**City of Portland, Maine - Building or Use Permit Application**

Permit No: 09-0228	Issue Date:	CBL: 342 B016001
-----------------------	-------------	---------------------

Past Use: 2 unit	Proposed Use: 2 unit - install a Hearthstone Homestead woodstove - in new addition connected w/ permit# 081480	Permit Fee: \$50.00	Cost of Work: \$3,000.00	CEO District: 5
Proposed Project Description: install a Hearthstone Homestead woodstove - in new addition		FIRE DEPT: <input type="checkbox"/> Approved <input type="checkbox"/> Denied <i>N/A</i>	INSPECTION: Use Group: <i>R3</i> Type: <i>Wood Stove</i> <i>NFPA 211</i> <i>IPC-2003</i> Signature: <i>JMB 3/24/09</i>	
		PEDESTRIAN ACTIVITIES DISTRICT (P.A.D.) Action: <input type="checkbox"/> Approved <input type="checkbox"/> Approved w/Conditions <input type="checkbox"/> Denied Signature: _____ Date: _____

**Jeanie Bourke - Re: NFPA 211-RE: 124 Allen Ave**

**Clearances from a Stove to a Corner**

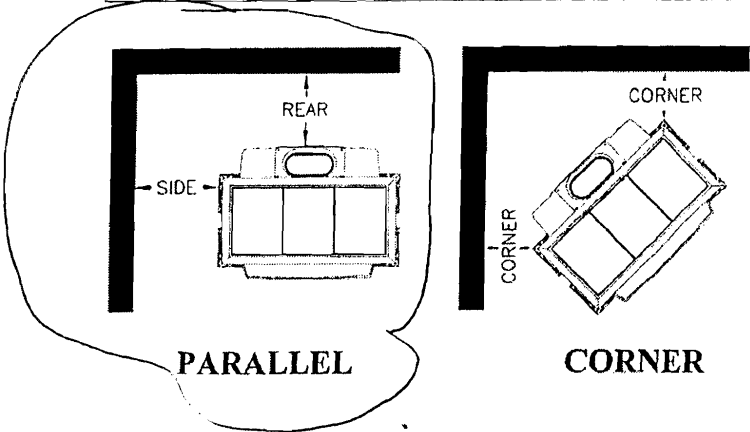
*Back w/ heat shield to sheetrock. The materials and installation were not per NFPA 211*

1. A heat shield will be used on the rear of the stove to meet the reduction to 13" to sheetrock per page 24 of specs.
2. The NFPA 211 procedure below will be used to treat the wall for reduction to the 24 guage single wall stove pipe for a distance of 9" to sheetrock.

North Elev

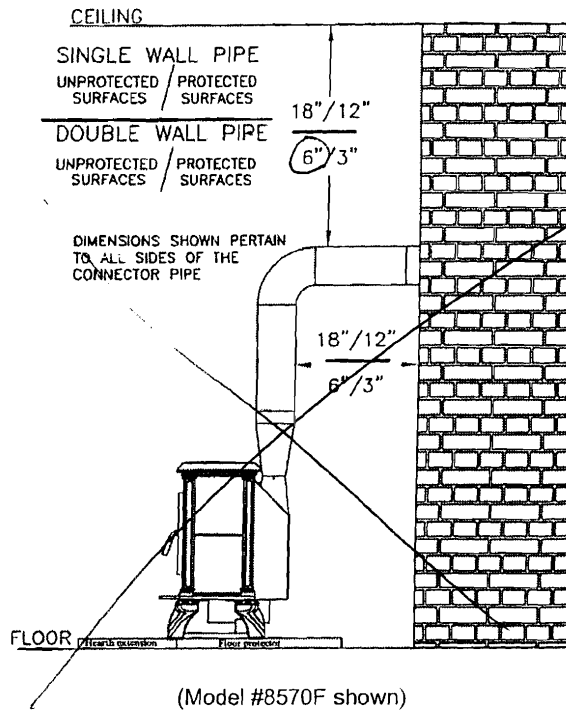
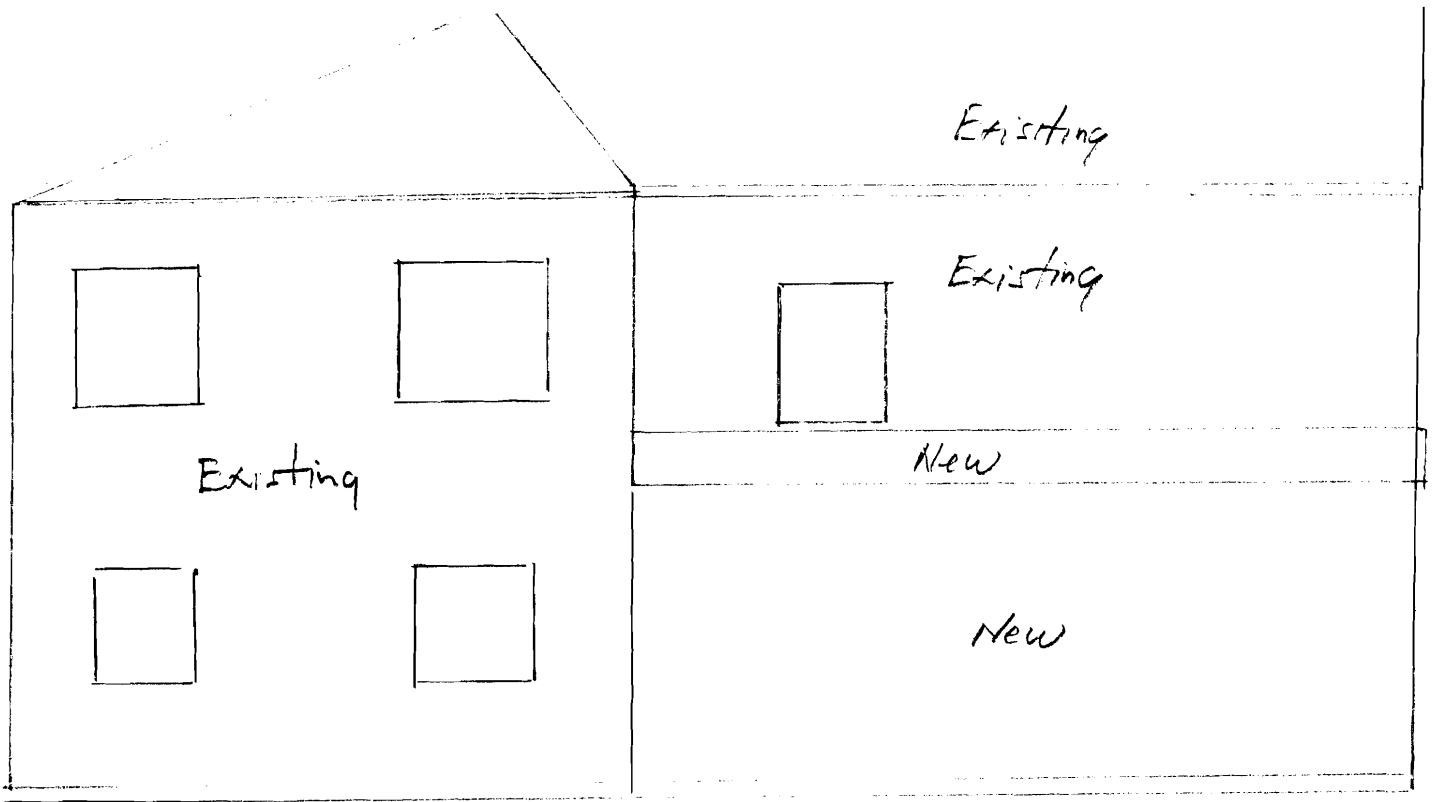
NFPA 211  
Table 6-5.1.2  
Reduces to 9"

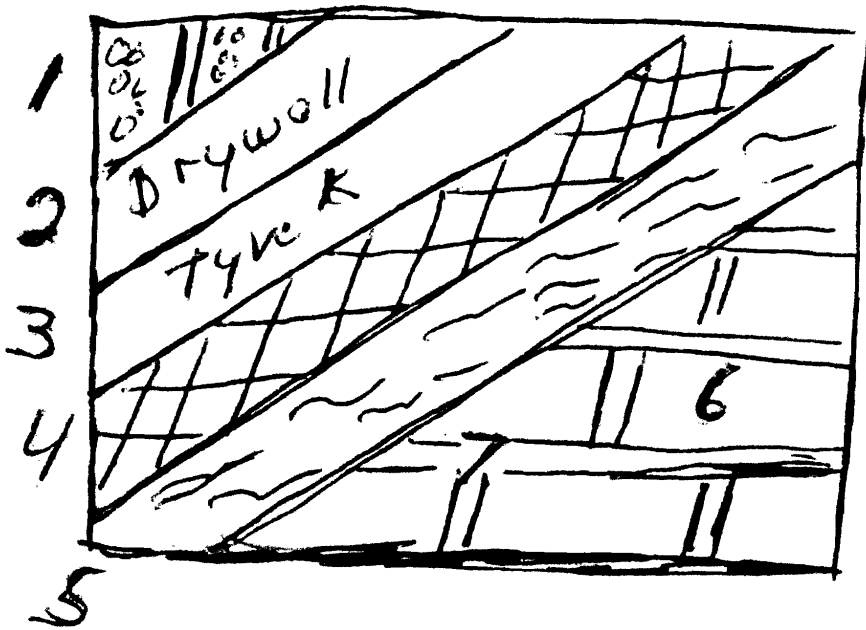
Preparation per Photos  
Does not meet

NFPA 211  
for reduction  
methods

Will install  
Heat shield per  
Stove specs  
to reduce  
to 12"  
to sheetrock
